Prepared for St. Luke's Grammar School
September 2020

SSDA Response to Submission (RTS)

New Senior School Campus

800 Pittwater Road, Dee Why NSW 2099

1.1 Second Lift

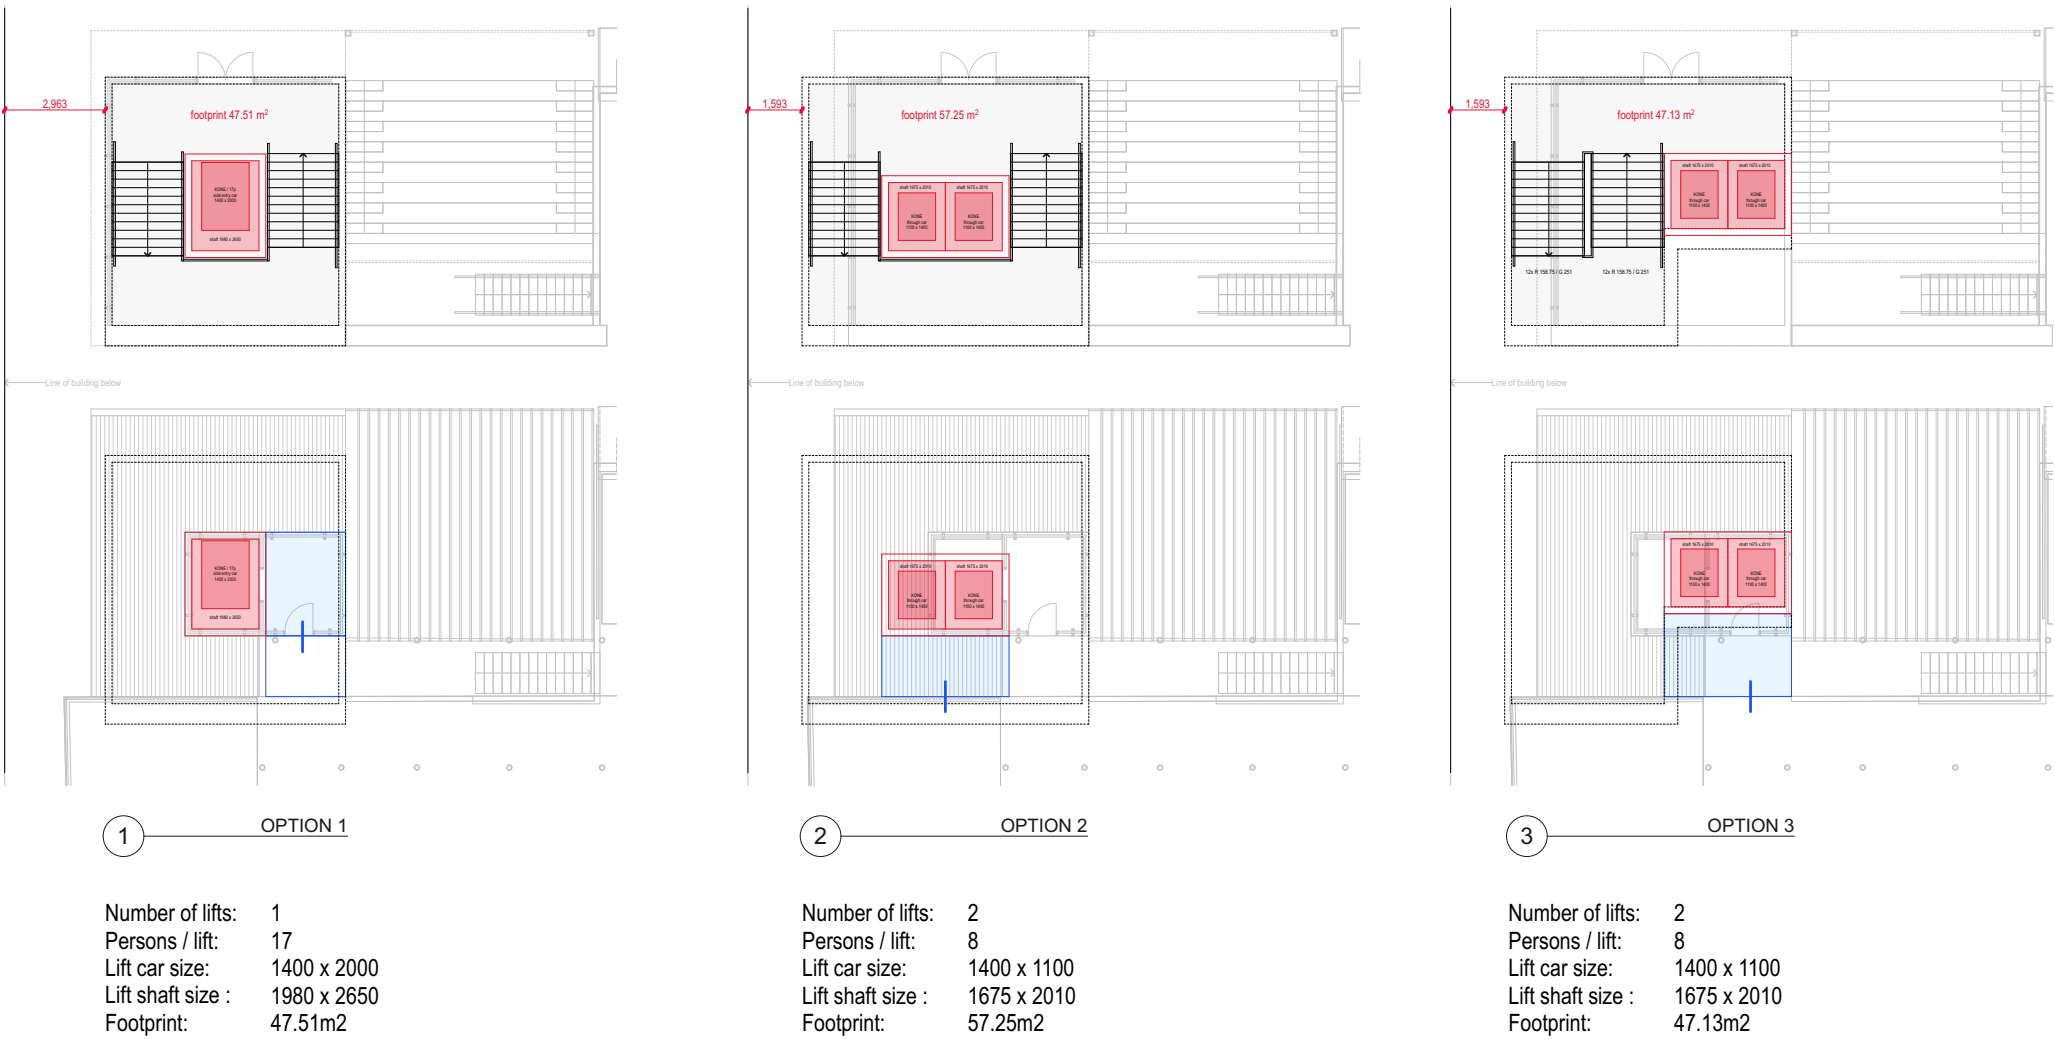
With just a single lift to provide this link, there is the potential to introduce a second lift in the main vertical circulation core to accommodate for the growth of student numbers over time. Given the scope and size of the campus and projected increase in numbers over time it would be prudent to provide several lifts.

The Department concurs with the comments from Northern Beaches Council (Council) regarding the provision of a second elevator to connect the two sites and the revision to the roofline at 800 Pittwater Road, and considers that this should be addressed in the RTS.

A second lift, with a reduced lift car size, can be accommodated without an increase in footprint area of the vertical circulation tower (refer Option 3).

To avoid a loss in width for the external social stair to the east, the circulation tower has to be moved west towards the existing building, which will decrease the set-back to the building from 2.9m to 1.6m.

The lift lobby at 224 Headland Road will move from the eastern side to the southern side of the lift.

Existing Option 1 - Acrylic top / Sandstone base

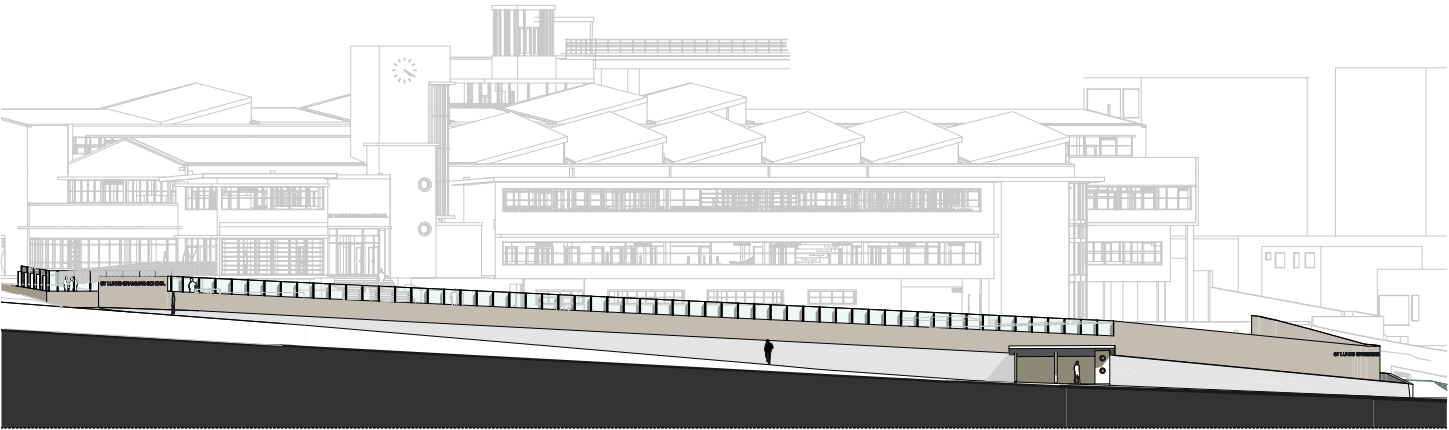
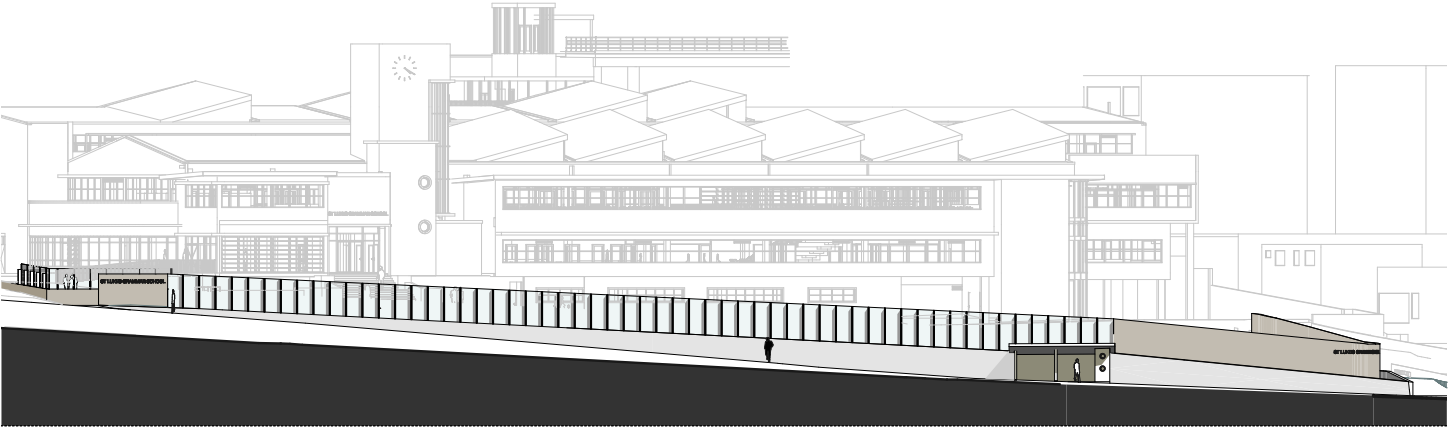
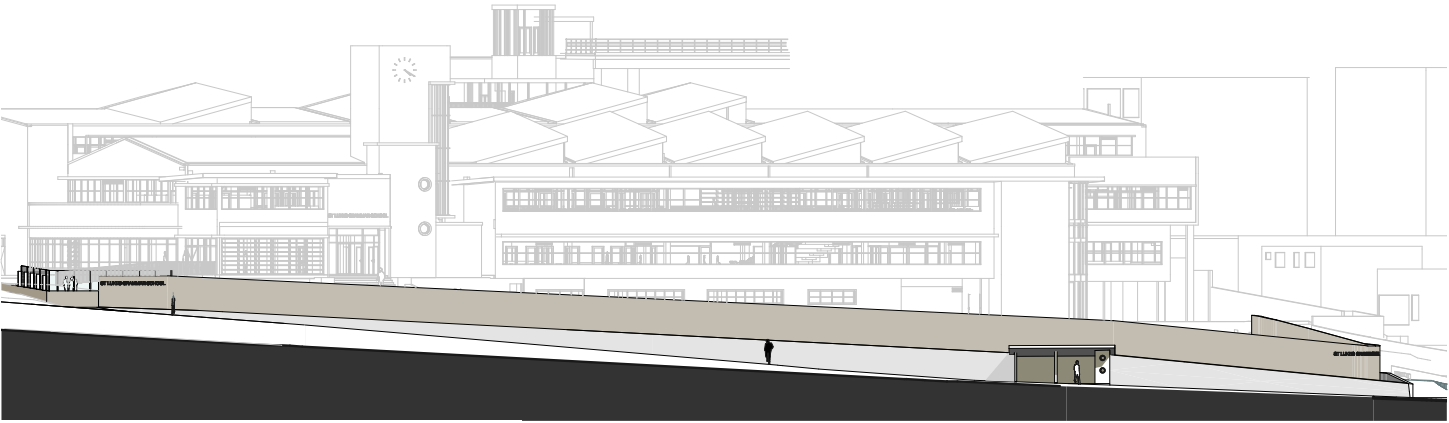
In concurrence with the Government Architect NSW (GANSW) comments regarding the use of the plexiglass fencing elements, there needs to be testing that looks to an alternate material. An alternate must sit in harmony with the sandstone elements and the greater natural landscape context of the natural podium whilst tying in with the form and architectural style and horizontal banding of the building expression could be further tested.

Council concurs with the comments of the GANSW on the plexi-glass noise wall barrier. This issue is complex as the plexi-glass offers a reduced bulk/ built form impact to the streetscape and views to the heritage building and is a well considered landscape response to the forecourt. Whilst noting support of deletion of the plexi-glass element, the applicant is encouraged to further test alternate options with the view to considering retention of the plexi-glass if further testing does not prove to result in a better urban design outcome.

Noting the variegated ground plan treatment of the landscaping that articulates is there an opportunity to provide a plexi-glass screen that follows this meandering line of articulation that can be planted

out with larger and smaller planting treatments at various points along this line to assist to soften the effect of a long straight plexi-glass wall. Possibly an option worth testing that could provide additional acoustic attenuation through the depth of planting and plexi-glass combined so as to break up the long linear elevation of plexiglass.

Prior to the lodgement of the EIS, the State Design Review Panel recommended the reduction in the use of transparent materials such as plexiglass or acrylic material. The design of the fence along Pittwater Road incorporates an acrylic material on top. The RTS should justify that the use of the material responds appropriately to the previous State Design Review Panel comments.

The GANSW comments were taken into account in the subsequent design development and the design team arrived at the proposed option with acrylic top and sandstone base. It was determined that the option best balances the requirements for visibility into the school, acoustic performance and integration into the landscape.

This option is preferred as it provides good visibility into the school grounds from the street which enables crime prevention through passive surveillance and aligns with CPTED (Crime Prevention through Environmental Design) principles.

The acrylic top with metal fins is preferred as it integrates the noise barrier wall into the overall composition of the development by utilising the architectural language of the proposed fenestration band in the western facade.

This option has been rejected as the extend of the acrylic material was not sympathetic with the heritage character of the site.

This option has been rejected as it does not comply with CPTED principles and does not fulfill heritage requirements of good visibility of the heritage item.

2.1 Location of Western External Walls

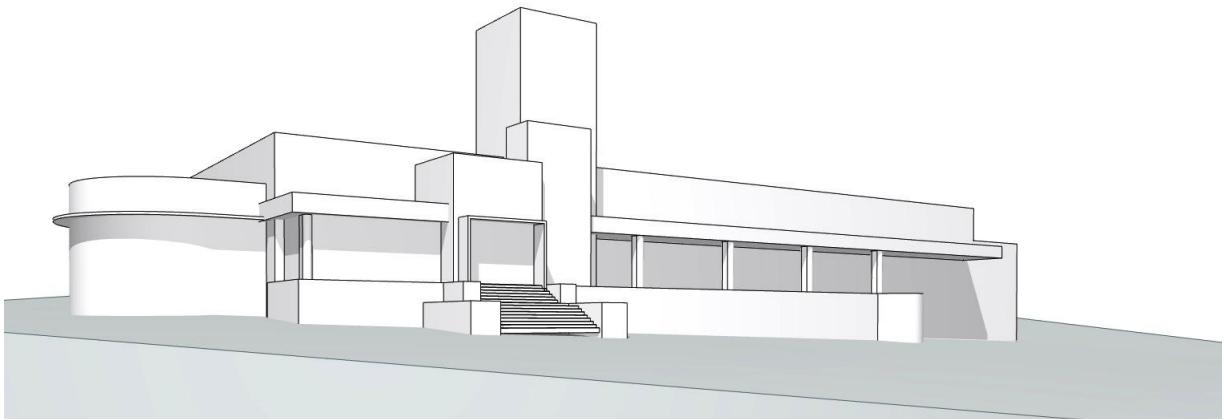
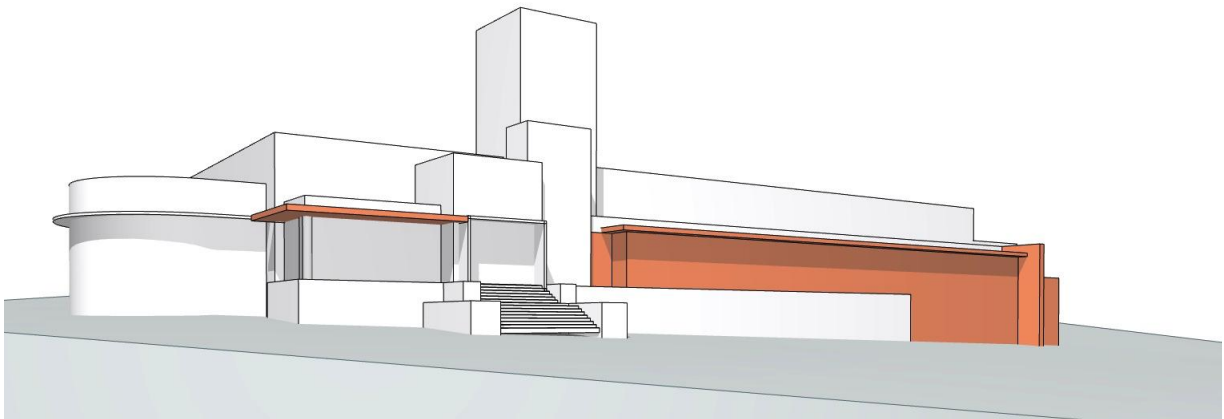
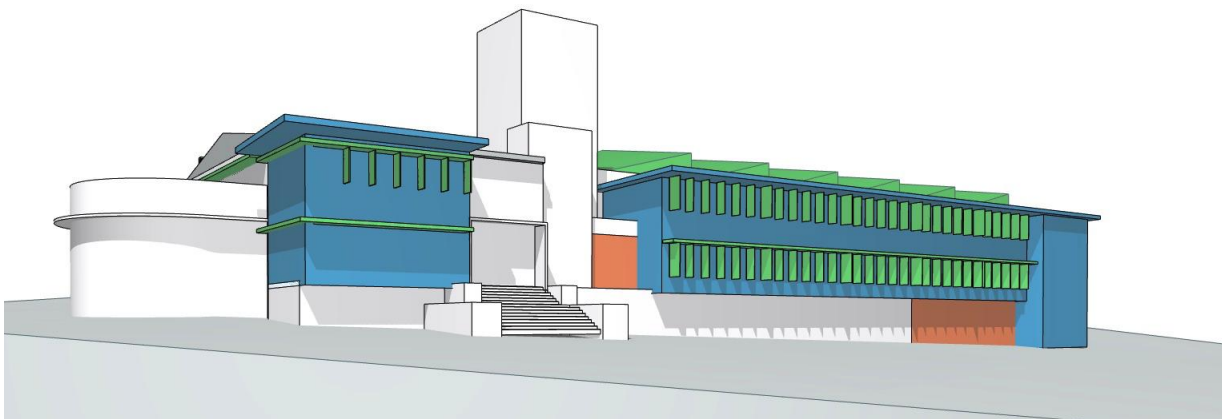
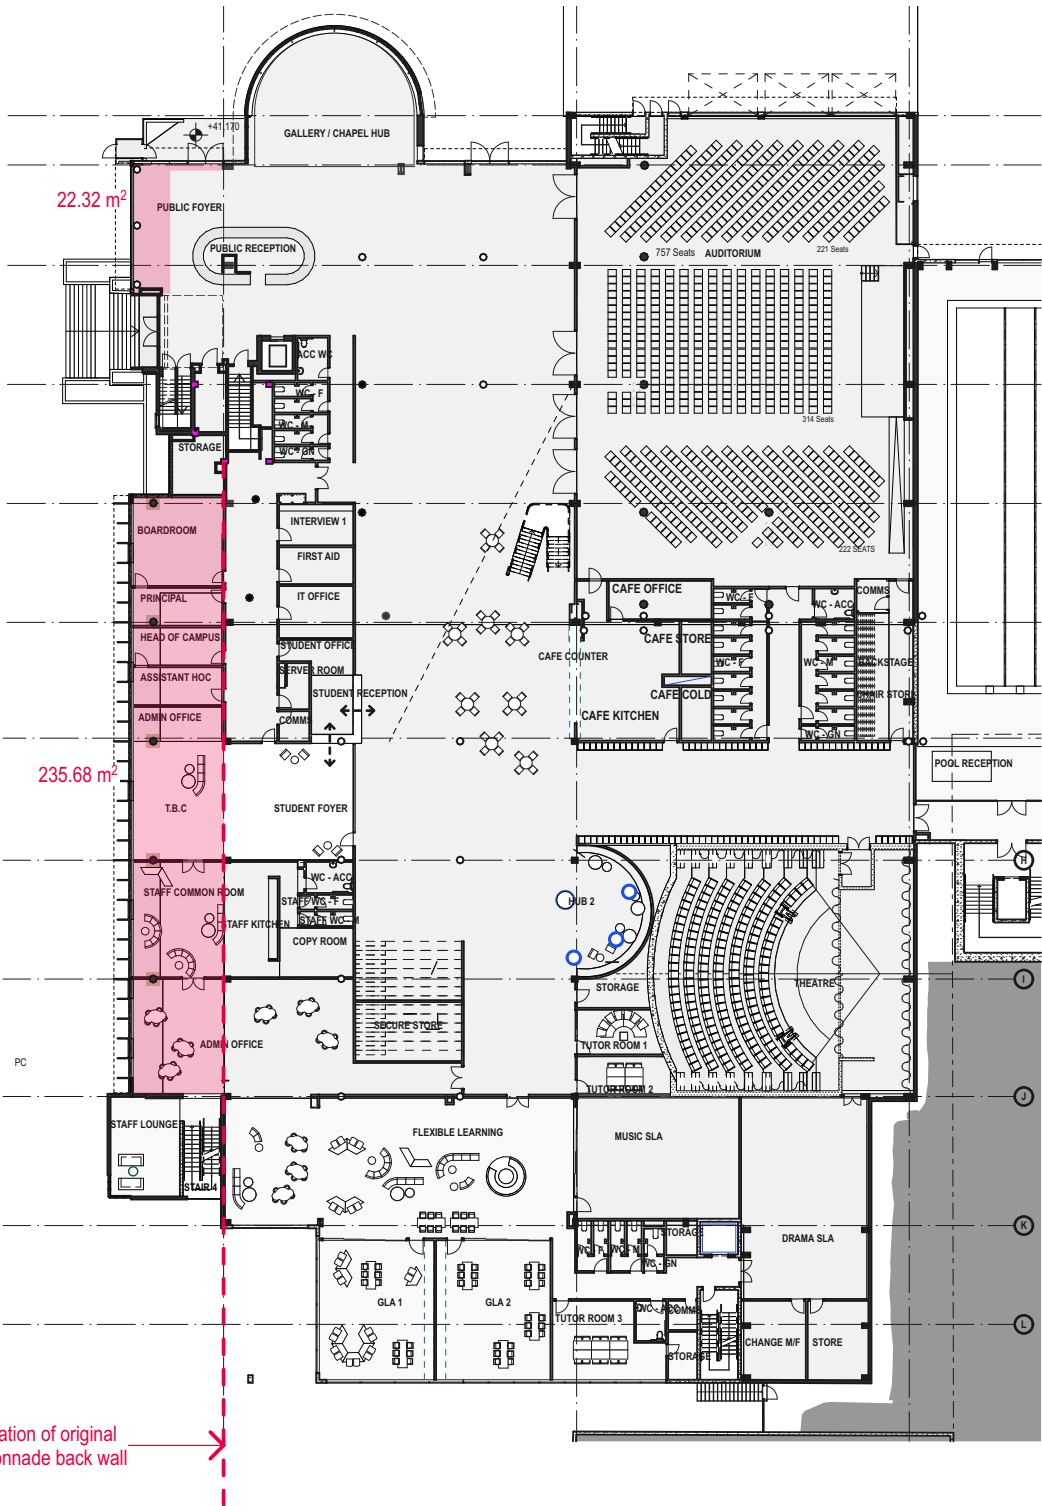
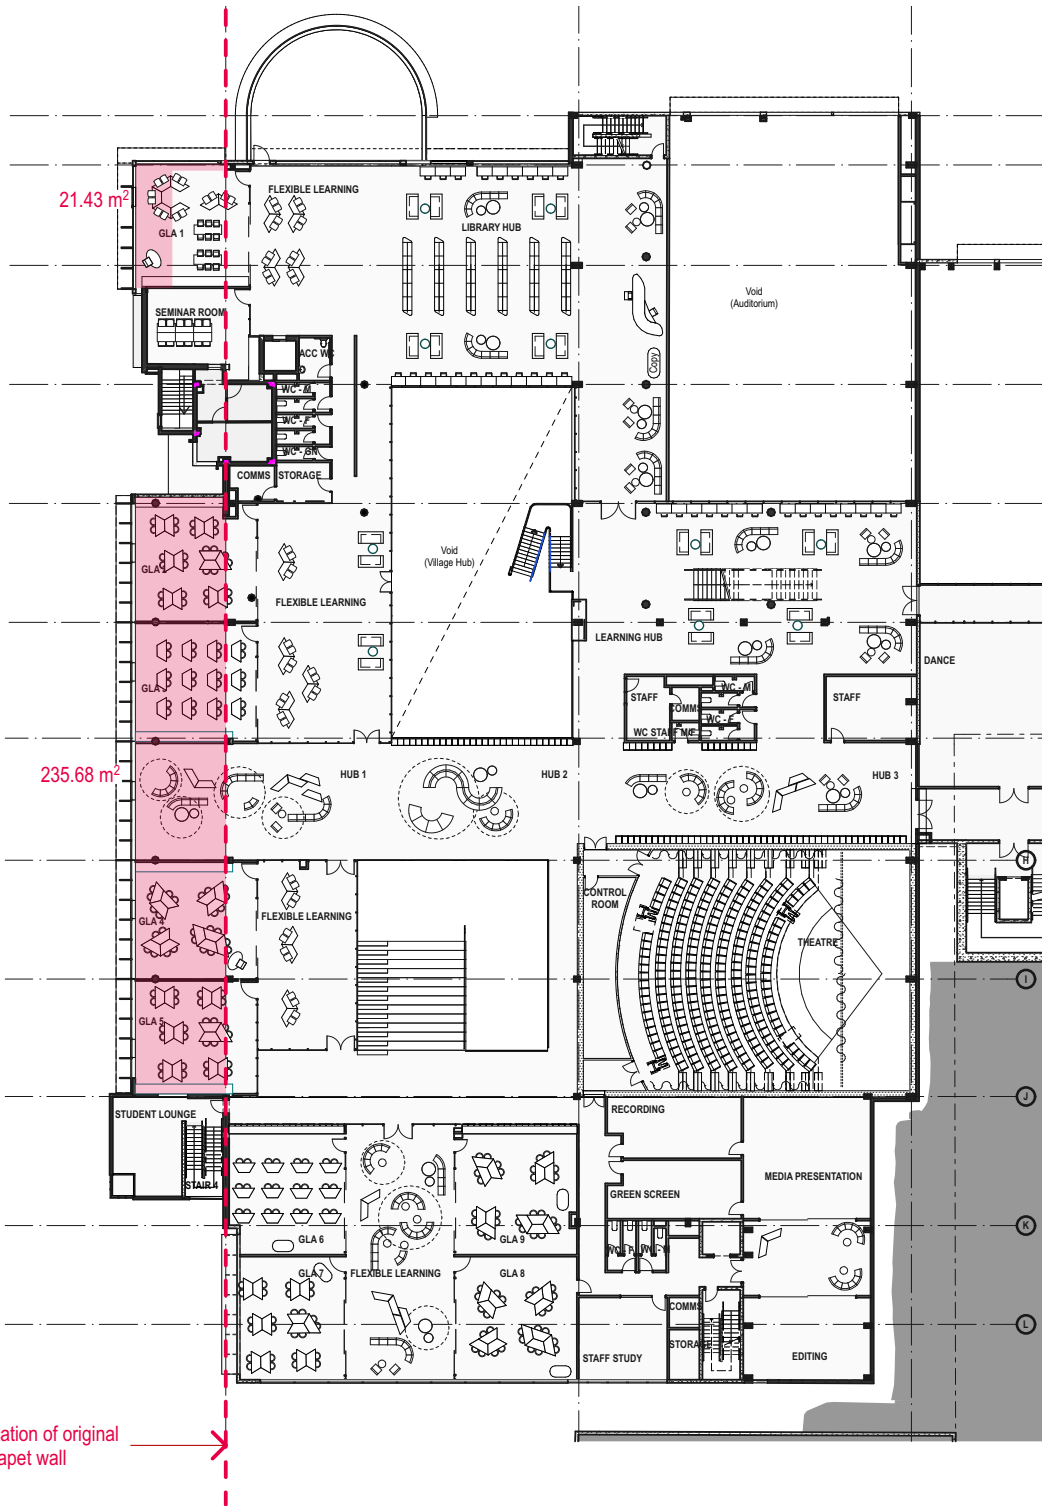
The new design fails to interpret the solidity and fenestration pattern of the original facade. The existing glazing on the western facade is proposed to be replaced with a new facade of solidity and fenestration which is not a lot different than the existing in terms of the location of the external walls. The original facade was located behind the leading edge of the clock tower with a parapet and recessed upper storey facade as well a large overhang. Similarly, the area to the left of the main entrance was also behind the leading edge of the tower. This original design ensured that the asymmetrical clock tower and building entrance took prominence as part of the original design, which has been lost in later additions. While the proposal does adopt a strong horizontal architectural statement, by adopting the line of the current Officeworks building for its new walls and large overhangs, this component will continue to

affect views to and from the clock tower. It would be preferable if the overhangs are removed and the upper section on the southern end recessed, thereby reinstating the original parapet wall. This will help to interpret the solidity and fenestration and the articulation of the original fabric. Slightly recessed glazing behind this parapet wall could complete the second storey. By doing this the proposed second storey area will need to be reduced (a reduction in the size of the proposed atrium may be considered to regain the required internal area). The original colonnade on the ground floor should be reinstated. This again will result in a slightly reduced internal floor area but will help the building to regain its original fabric on the western facade. A similar design approach should apply to both sides of the main entry on the western facade, so as to retain the prominence of the tower element and also retain significant views to the tower and to the semi-circular canteen element at the north-west end of the building.

The view study illustrates the history of the building alterations since the opening of the original Top Dog Men’s Wear factory in 1949 and explores the impact to the obstruction of views to the clocktower and the semi-circular canteen element the later alterations impose.

The Northern Beaches Council recommendation to reinstate the original parapet wall on Level 2 and the colonnade on Level 1, would require significant restructuring of fabric demolished in 1998.

The view study shows that the 1950’s and 1993 additions and the proposed works, do not affect the views to the clocktower and canteen when approaching from Warringah Road, which is the main view of the building. The views are slightly improved when approaching from Pittwater Road or from Harbord Road.

The GFA loss resulting from the set-back of the western facade walls as per Council’s recommendations amounts to more than 500 m2.

To re-instate the original colonnade on Level 1, the administration area would have to be reduced by ~235m2 and the public foyer area would have to be reduced by ~22m2. The remaining floor area would be insufficient to fit the required accommodation.

To re-instate the original parapet wall on Level 2, the general learning areas (GLA’s) would have to be reduced by ~255m2, which will result in the loss of 5 GLA’s. This remaining GLA’s will be insufficient to fit the required number of students and does not meet the educational requirements.

We conclude that the benefits of retaining the existing structure far outweigh the advantage of improving the views to the clocktower and canteen.
